PRODUCT CHANGE | VEUE Wire Guide Top Terminal

TRANSITIONING.	June 2022

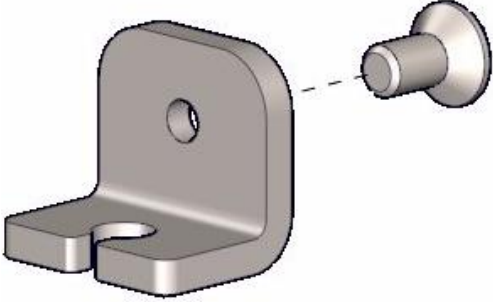
- New conical design to prevent the Swaged Dome Terminal pulling through.
- Increased tension adjustment range of spring.
- Spring & Saddle Bracket supplied together to reduce SKU's.
- Increased inner pack to 8x sets, reduced outer pack size to 200x sets.
